**STATE OF CONNECTICUT
SITING COUNCIL**

Connecticut Siting Council	:	Docket No. F-2008
Review Of The Ten-Year	:	
Forecast of Connecticut Loads	:	August 14, 2008
And Resources	:

**COMMENTS OF THE CONNECTICUT ENERGY ADVISORY BOARD
ON THE CONNECTIUCT SITING COUNCIL'S
FORECAST OF CONNECTICUT LOADS AND RESOURCES
2008 DRAFT REPORT**

Exhibit 3

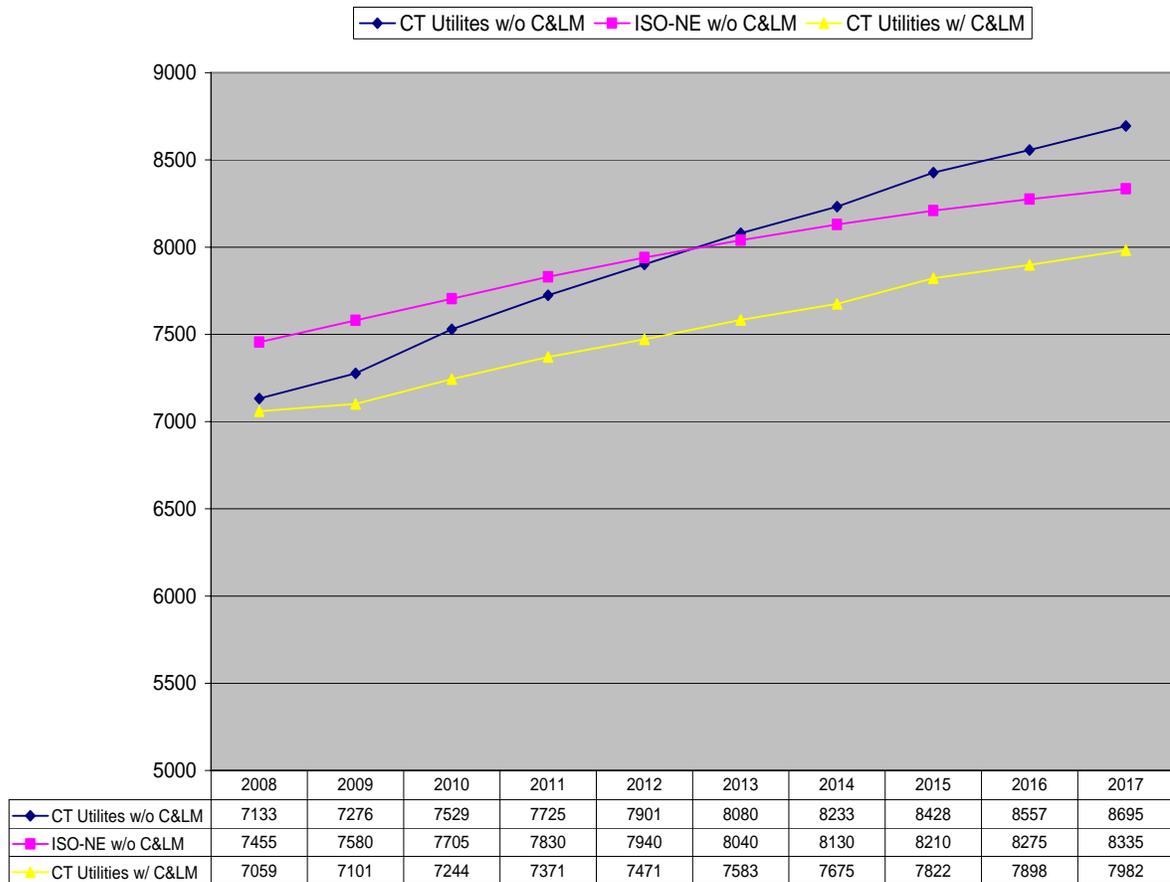
Next, relative to Figure 1b on page 6 of the Draft Report, it would be appropriate to remove the top curve entirely or to replace it with the new data (shown in Exhibit 3 below), which exclude new C&LM and include C&LM impacts from existing programs.¹⁰ The reason this would be proper is that none of the forecasts in the record exclude the impacts from existing programs and measures.¹¹ Thus, it is not necessary to include a curve showing the EDC forecasts with no existing or new C&LM. In addition, the CEAB believes that the top curve shown in Figure 1b “includes” forecasted

impacts from historic (pre-2008) programs that are in place only for CL&P, which may double count these impacts, since the impact of existing C&LM measures are embedded in the historical data used to estimate the EDC's forecast models.¹²

The last two rows of the data table above replicate the data from Figure 1b in the Draft Report. As the exhibit demonstrates, the ISO-NE's forecast exceeds the EDCs' forecast by about the same amount each year (corresponding to an annual impact, on average, of 429 MW, which is similar to the average annual sum of about 435 MW in assumed impact

from DG and C&LM reported by CL&P, UI and Connecticut Municipal Electric Energy Cooperative's ("CMEEC"). However, the curve expressing the EDCs' forecasts without C&LM shows that the rate of implementation of C&LM increases from year to year. Thus, the EDCs' are forecasting a much faster rate of growth in underlying peak demand, which requires more resources (both demand and supply) to serve this peak demand the farther out in the forecast period.
